Service Bulletin

13-079

Applies To: 2010-12 Crosstour V6 - Check the iN VIN status for eligibility

Warranty Extension: MIL Comes On With DTCs P0301 Through P0304 (Supersedes 13-079, dated October 8, 2013, to revise the information marked by the black bars)

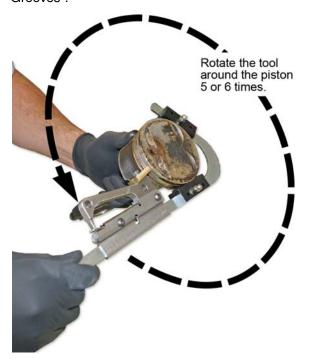
Under PISTON CLEANING PROCEDURE, information was updated.

Hold the piston steady and rotate the tool counter-clockwise five to six times to remove any carbon deposits in the piston ring grooves.
 Do not rotate the tool clockwise.
